BERP
HOLLEY HALL

BALCONY WINDOW PROTECTION

SK-02

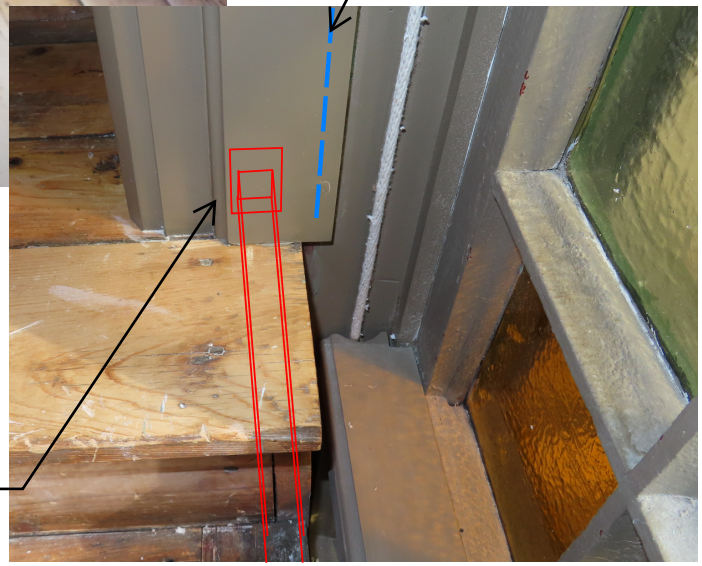
(5) 1" SQUARE STEEL RAILS MOUNTED IN FLANGES, SCREWED TO JAMB. ALIGN RAILS WITH WINDOW LIGHT PATTERN AS SHOWN. PAINT FLANGES AND RAILS TO MATCH PEWTER TRIM COLOR.

PROPOSE TO USE SAME FLANGE AS AT LIBRARY STAIR - SIMILAR TO THIS

SET FLANGE NEAR FRONT OF JAMB TO KEEP CLEAR OF BLIND DROP. COULD POSSIBLY SHIFT BLIND HOUSING MOUNTS BACK A LITTLE IF CONFLICTING.
